# 3138 WETMORE AVE. S

## ADMINISTRATIVE DESIGN REVIEW

PROJECT NO. 3034544-LU

## Design Review Recommendation Packet

**Design MUP CYCLE 4**  
RENDERED ELEVATIONS/MATERIALS

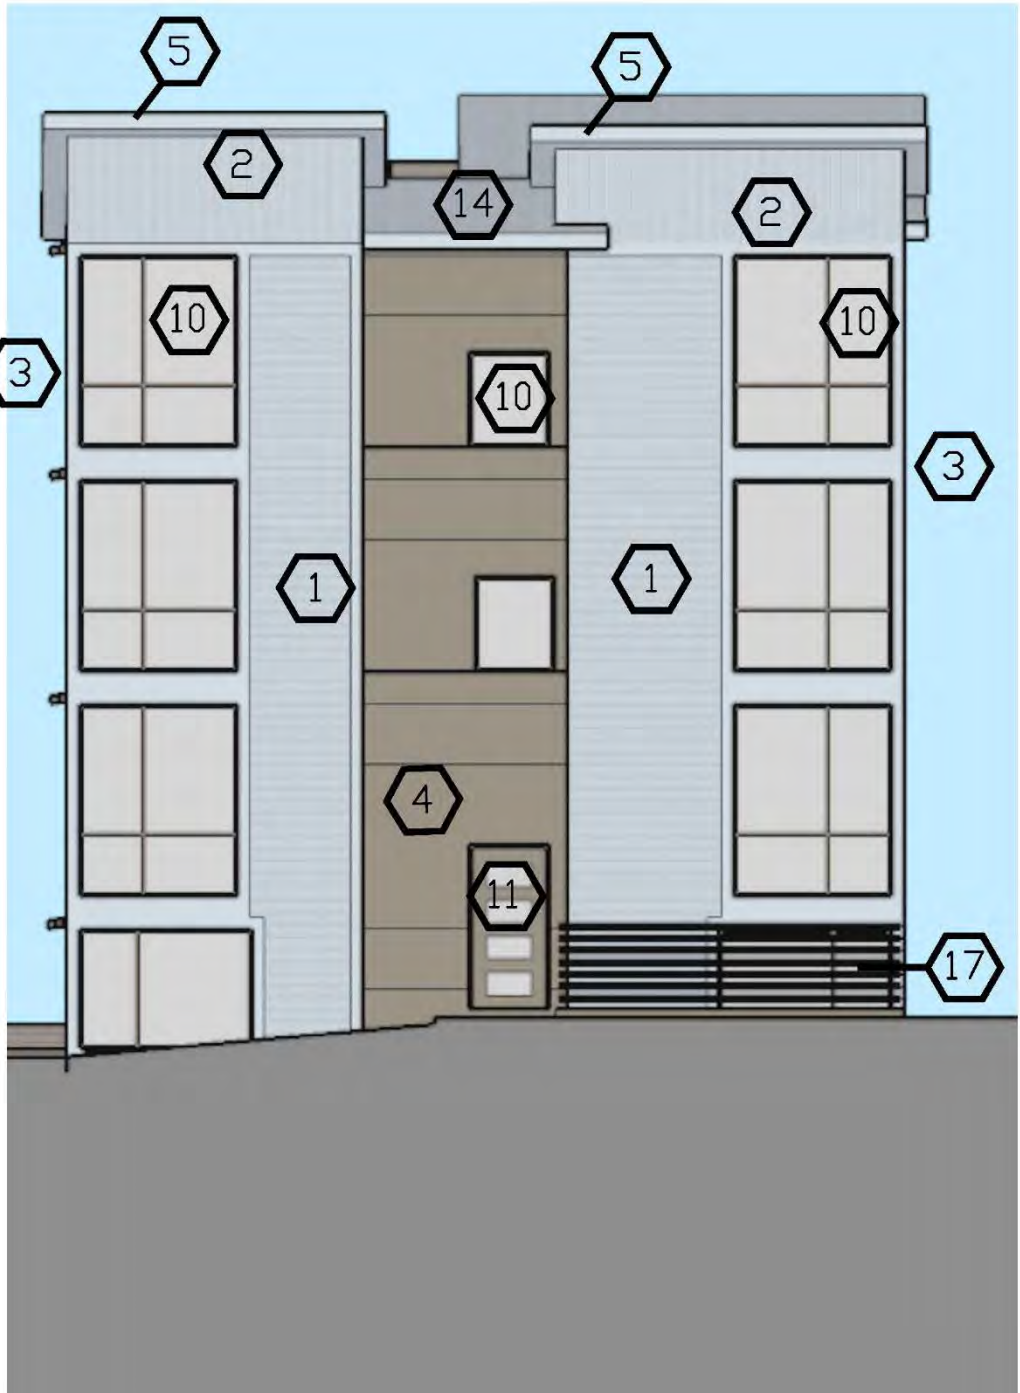
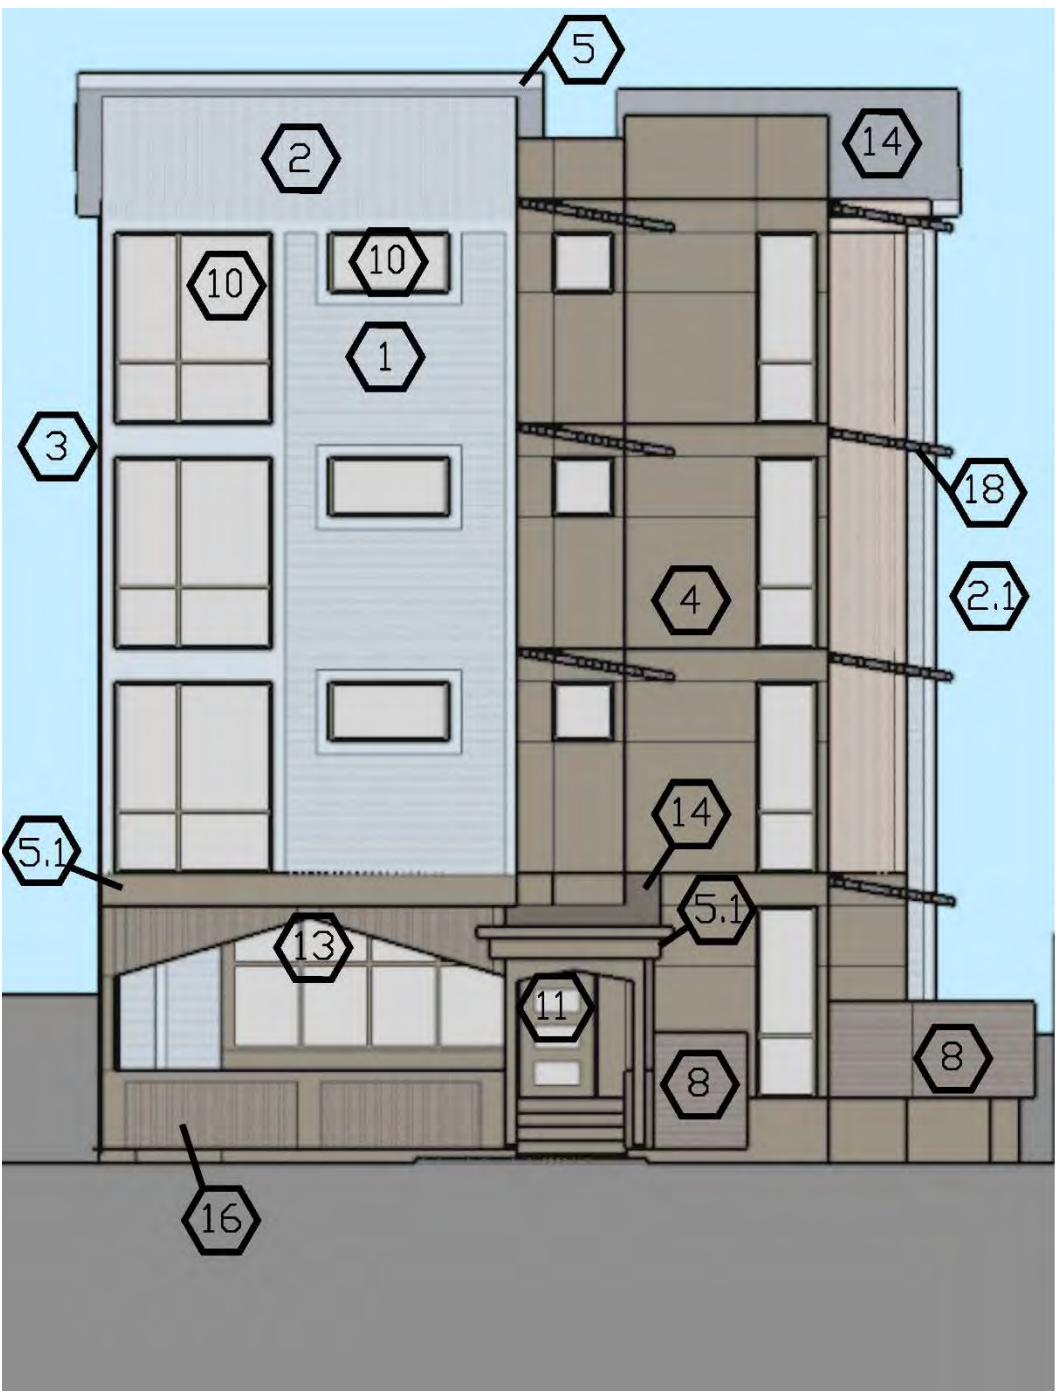
5	Staff supports the large glazing on the street façade and the large glazing in the lobby (PL2-B-1)	Acknowledged.
6	Staff supports the stepping modulation away from the street but encourages the material palette to be simplified while continuing to offer residential Design Review Recommendation-Materials-For the MUP/Recommendation phase, all exterior materials must be specifically identified, by either manufacturer and product name or with a complete specification that includes material composition, dimensions, thickness, gauge, (for metal), grade, color, etc. Please include photos of the color and materials palette in the Recommendation Packet and bring physical color and materials board to the Recommendation meeting (or submit to SDCI for ADR projects). Please follow the Applicant Guide to prepare and submit you materials board.	Acknowledge, material palette has been simplified while using exterior finish materials consistent with residential character.

### MASSING OPTION 3.

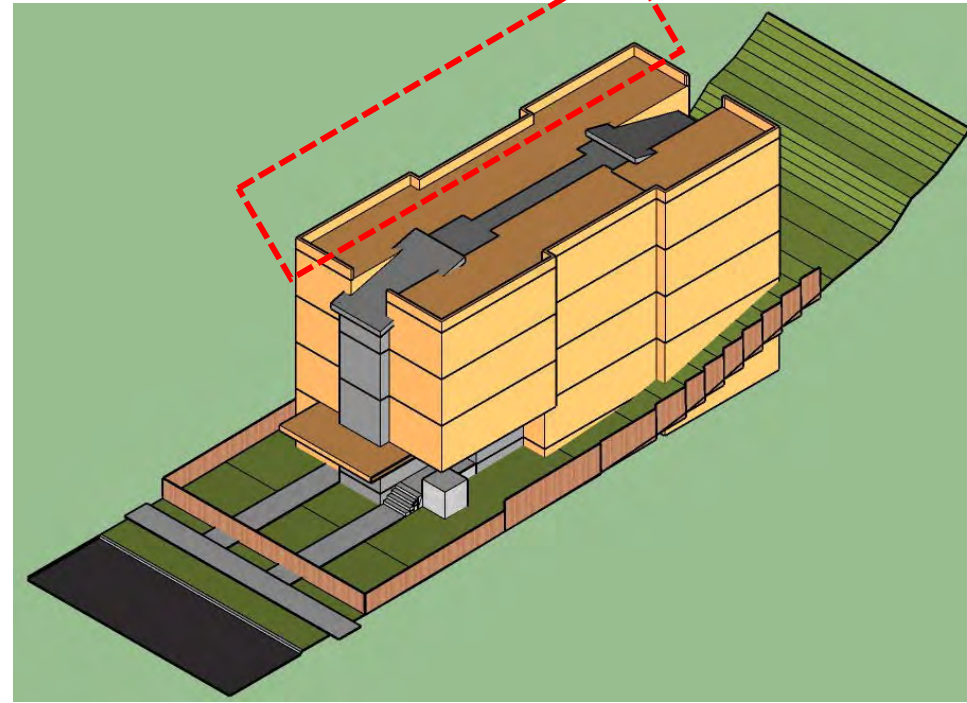
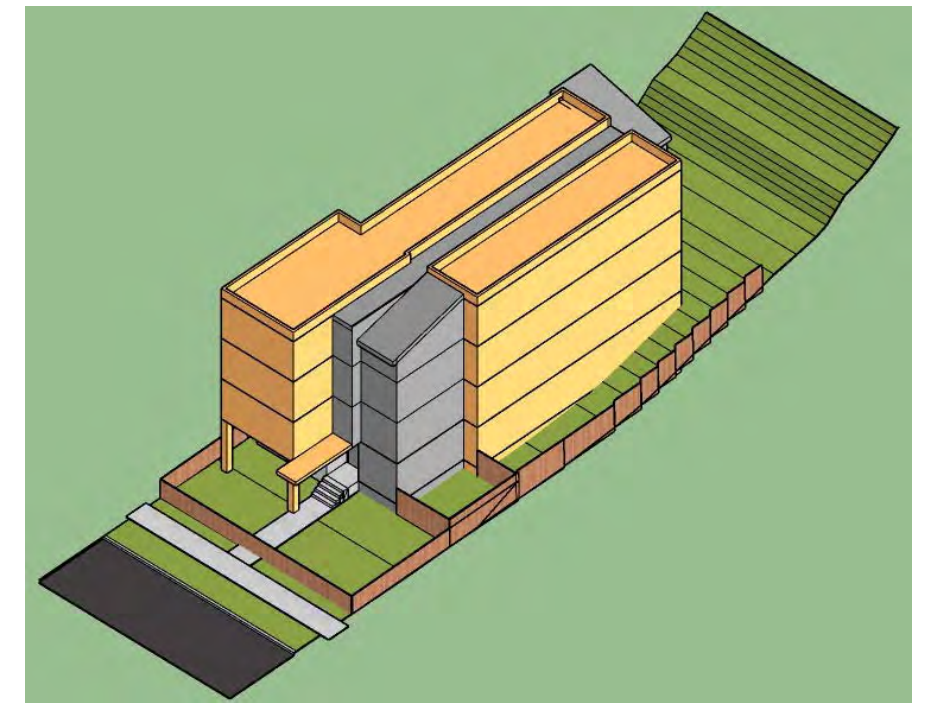
ADMINISTRATIVE EDG REVIEW-STAFF SUPPORTS MASSING OPTION 3, WITH ADDITIONAL "STEPPING" OF THE NORTH FAÇADE, SIMILAR TO OPTON 2.
